Zoning Staff Report

Case Number: ZC-25-050

Zoning Map Amendment & Site Plan

Site Location: 2900 - 3000 (evens) N. Commerce Street

NORTH STOCKYARDS MULTI-FAMILY PD SITE PLAN

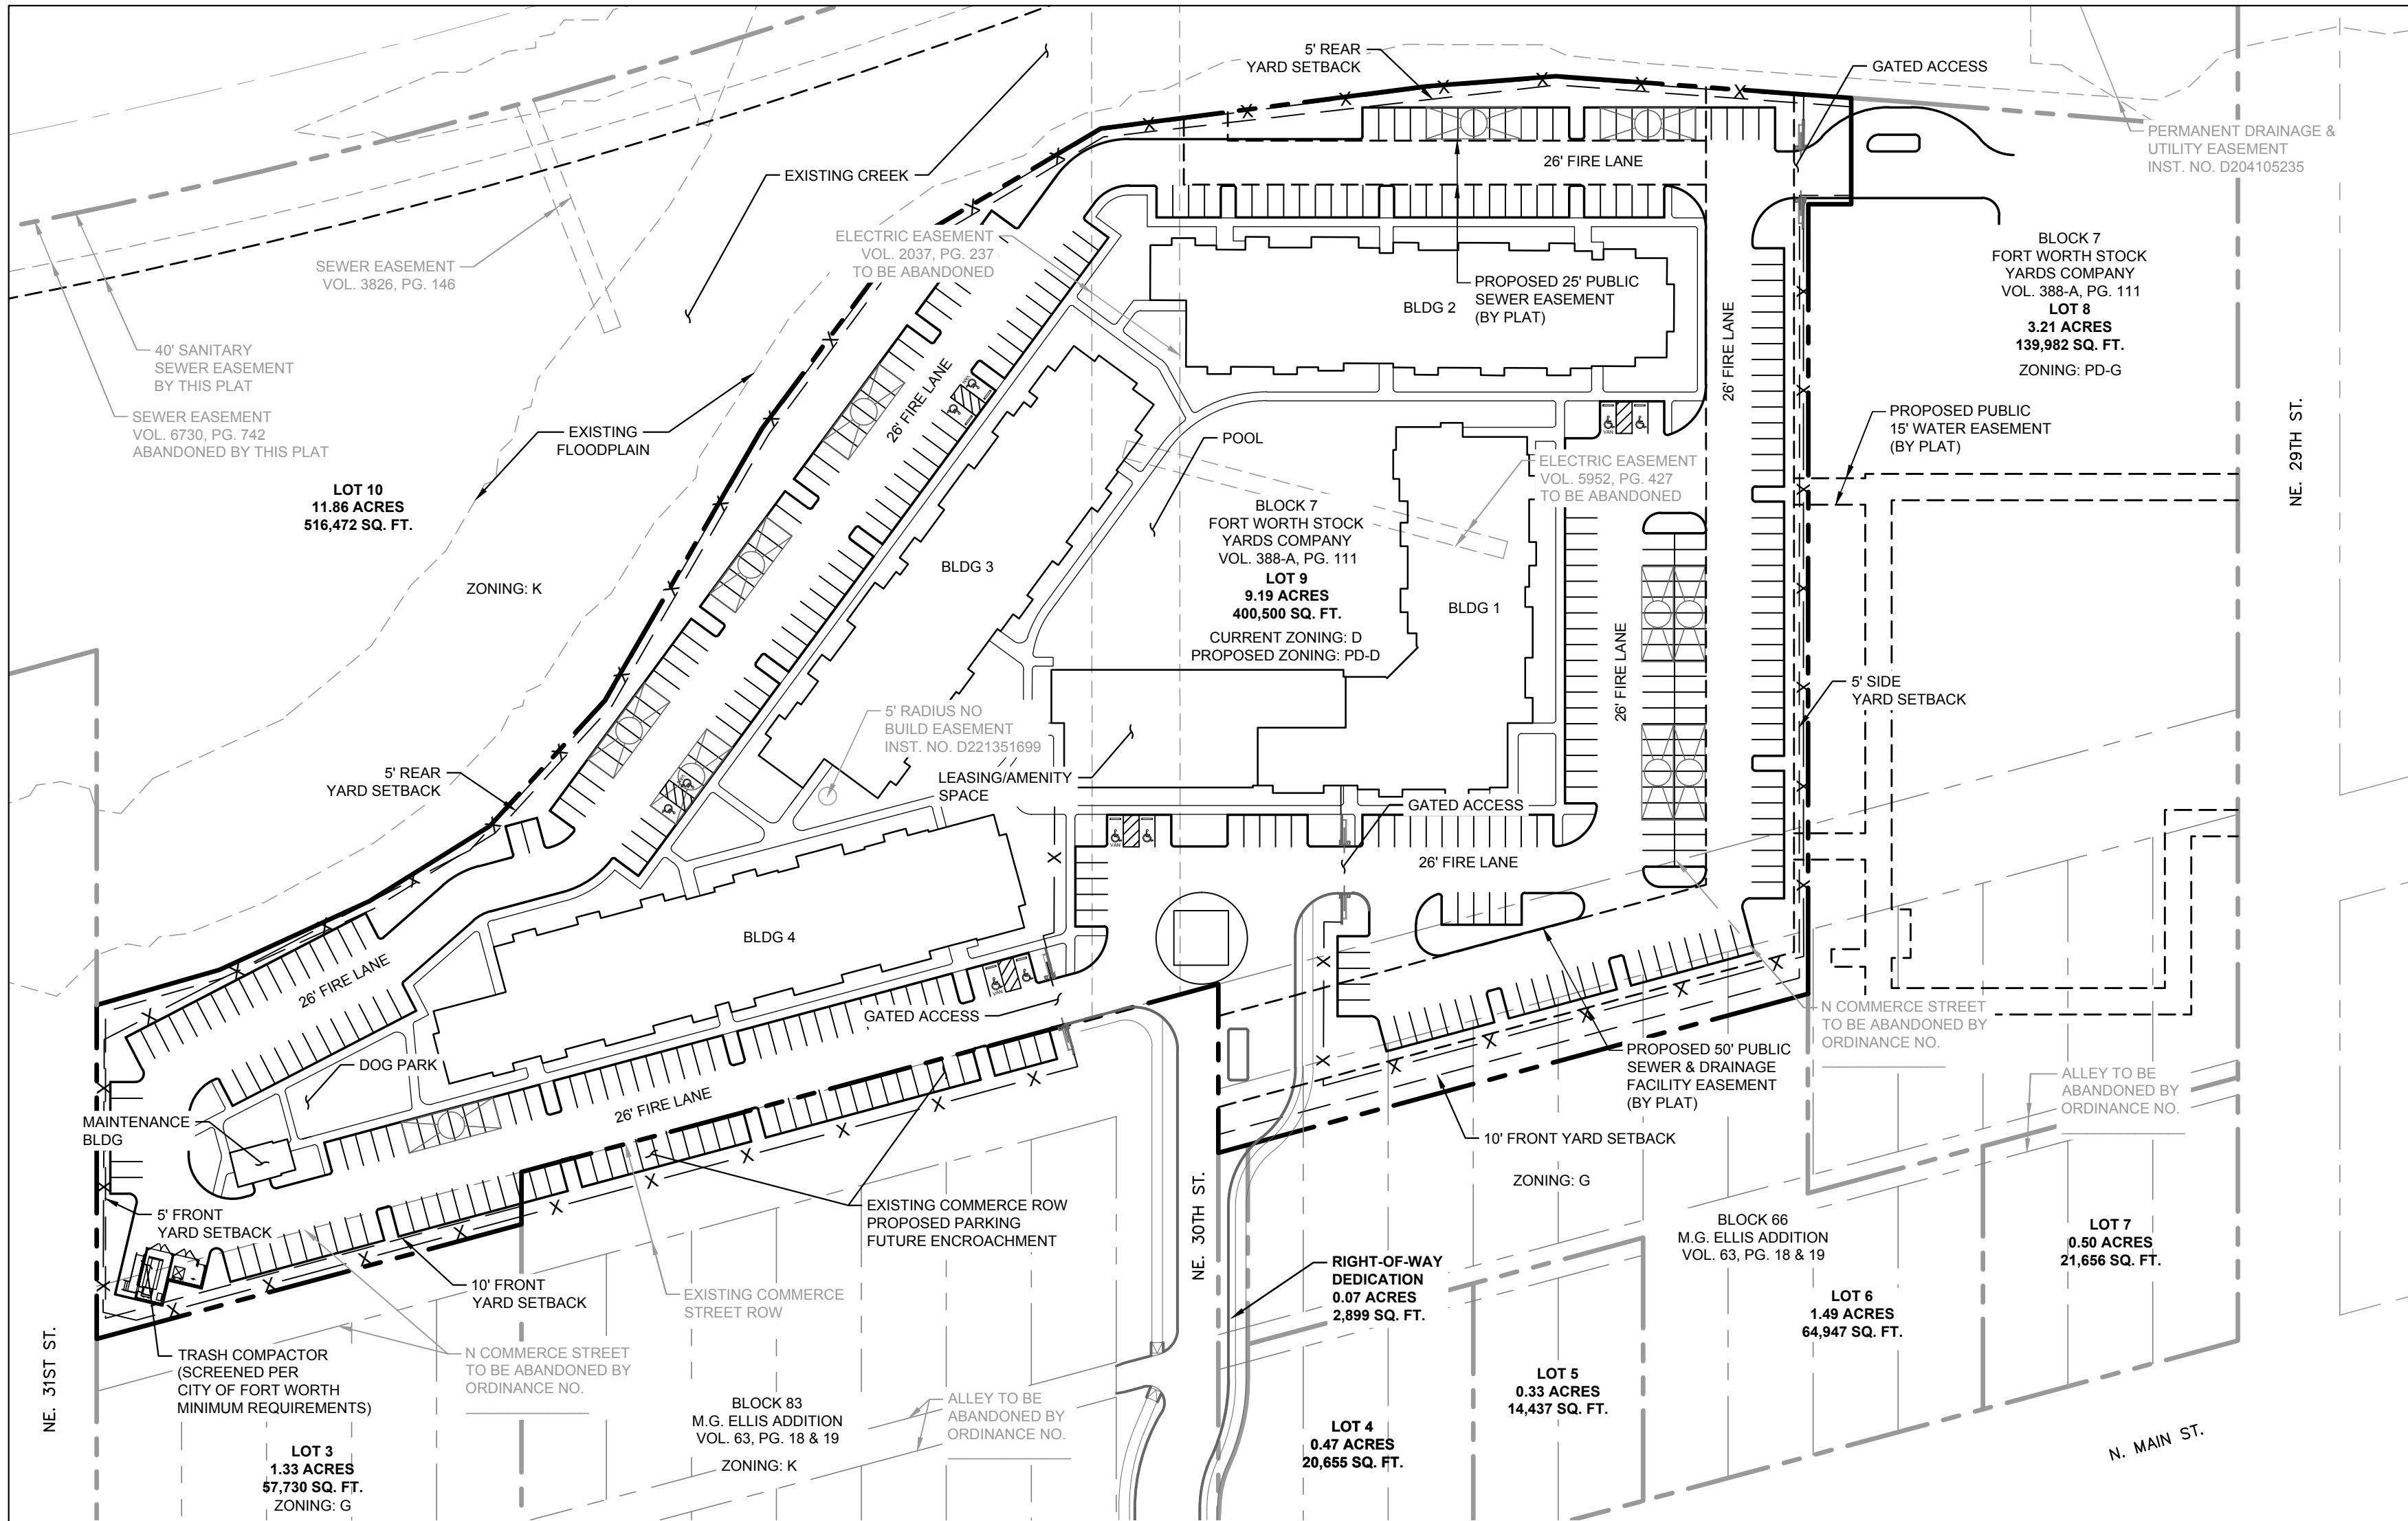
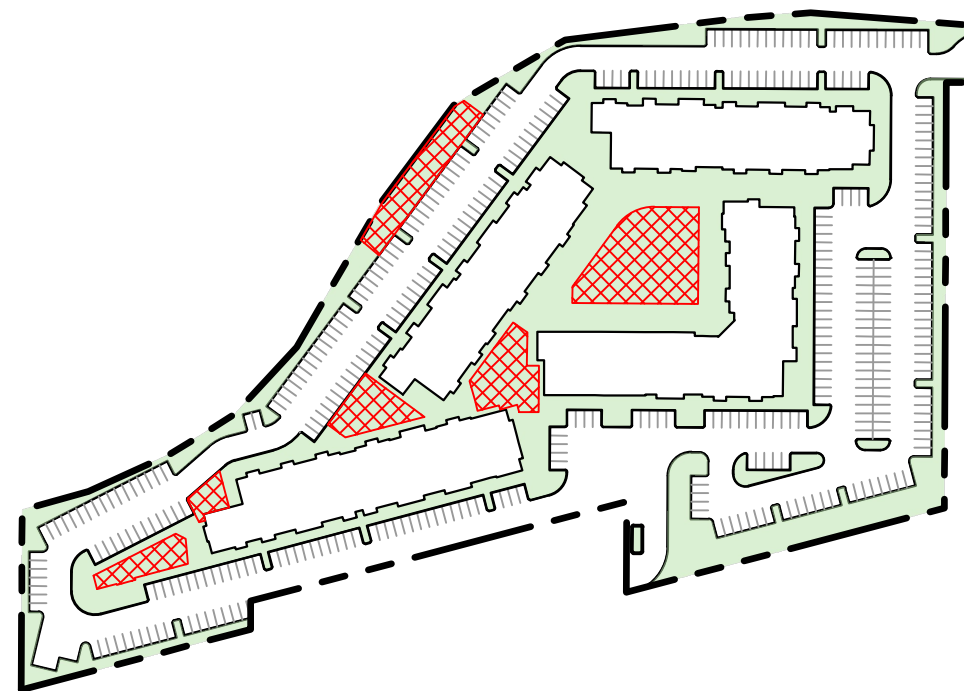
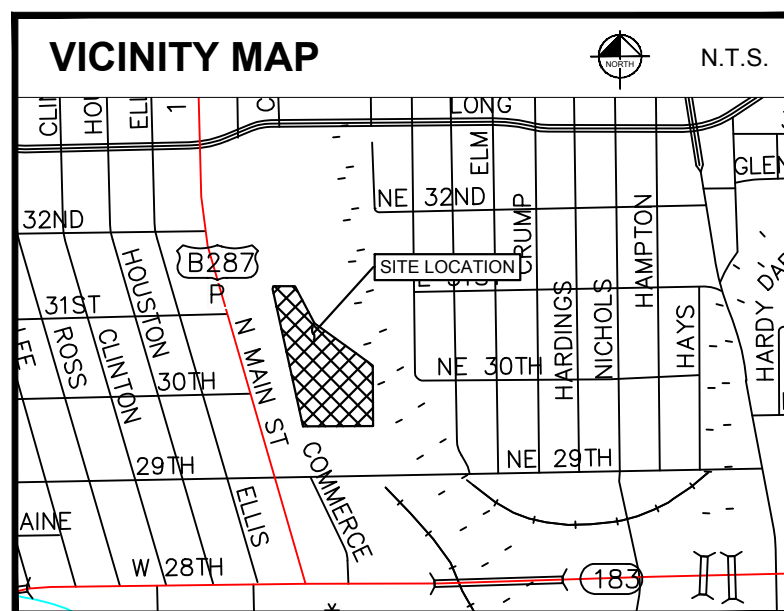
The proposed reduction of 42 required parking spaces could adversely impact future residents and strain parking availability for nearby businesses and homes. Staff recommends compliance with standard parking requirements to ensure adequate on-site capacity and to minimize potential overflow onto surrounding streets.

Additionally, carports and parking should be located behind the buildings and screened from public view to maintain a walkable, pedestrian-friendly streetscape and preserve the neighborhood's visual character. Rear parking also provides a beneficial buffer between residents and the adjacent railroad, helping to mitigate noise and other potential disturbances.

Lastly, the proposed fencing between the building and the property line undermines the applicant's stated goal of promoting connection and walkability by creating a physical barrier rather than facilitating access. This design choice would restrict residents' ability to easily reach the Northside TEXRail Station and other public

transportation. Additionally, the current site plan only provides for vehicular access and lacks clearly defined pedestrian pathways. As shown, residents attempting to exit the property on foot would need to cross four rows of parking, also staff has not identified any sidewalks or safe pedestrian crossings in the layout. This absence of pedestrian infrastructure represents a missed opportunity to enhance walkability and connectivity in the area.

Requirement	Proposed PD/D (Provided per site plan)	Staff concerns
Units per acre	33 maximum	No Concerns
Setbacks	To allow NE 30 th Street to be considered the only front for the setbacks requirements	No Concerns
Parking	Reduce of parking spaces to 1.4 parking spaces per unit and none for common areas, offices and recreation	Yes, there is concern. Staff recommends keeping the requirement at 1 space per bedroom plus 1 space per 250 square feet of common areas, offices and recreation (less laundry rooms and storage)
Carports /Parking	Carports and parking shall be allowed between a building and a public or private street,	Yes, there is concern. Carports and parking should be located behind the buildings and screened from street view to maintain a clean, pedestrian-friendly streetscape and preserve the visual character of the neighborhood.
Fences and gates	Fences shall be allowed in-between the building and property line	Yes, there is concern, as it would negatively impact potential future residents by creating a physical barrier and discourage connectivity.

In conclusion, while the proposed use is compatible for this area, the associated waiver requests raise notable concerns. To ensure the long-term success of the project and its integration into the surrounding community, staff recommends that the applicant revise the proposal to comply with parking, carport and parking location and fencing.
